Title: AUX FEED WATER PUMP P-38B MINIMUM FLOW RECIRCLINE ORIFICE

PLANT MODIFICATION NO.: 99-029\*B

**FINAL DESIGN DESCRIPTION  
MODIFICATION REQUEST 99-029\*B**

## SKETCH 1

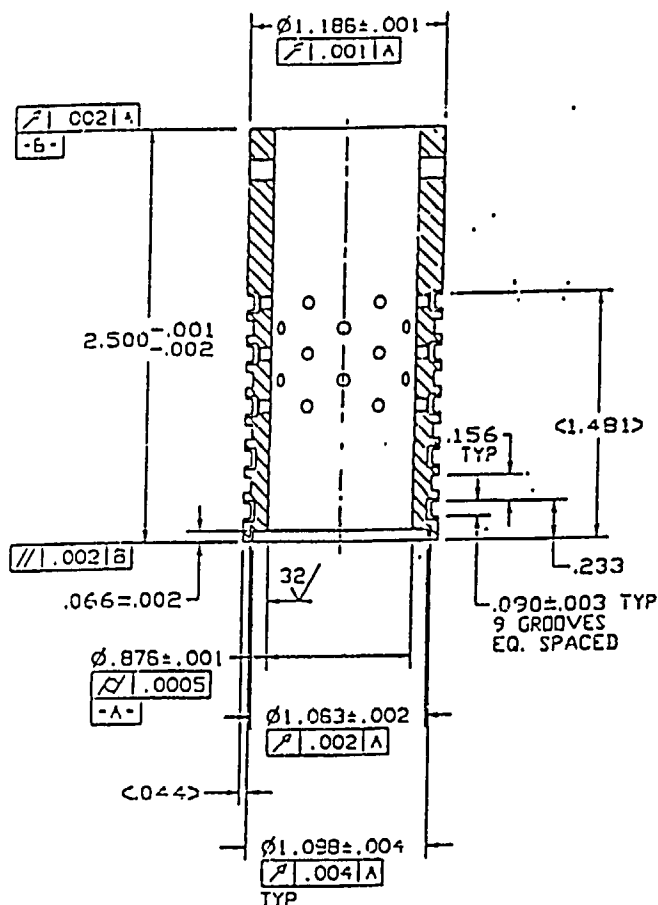
| 9.0 | <p>Drill <del>four</del> <sup>5 in (6) 5th</sup> additional 0.076 +/- 0.002 (#48) holes as shown<br/>on the attached marked up sketch 1 of the innermost (6<sup>th</sup>) stage of the seat<br/>retainer (30) and remove any burrs.</p> | <u>MB 11/10-00</u><br>MTN/DATE |

(30)  
54X  $\varnothing .076 \pm .002$  (48) THRU  
 $\varnothing .125$  (1/8)  $\nabla .071$  (54 HOLES)  
5 ROWS, 6 HOLES/ROW.  
CENTERED IN CHANNEL

POINT BEACH TO  
DRILL THESE HOLES
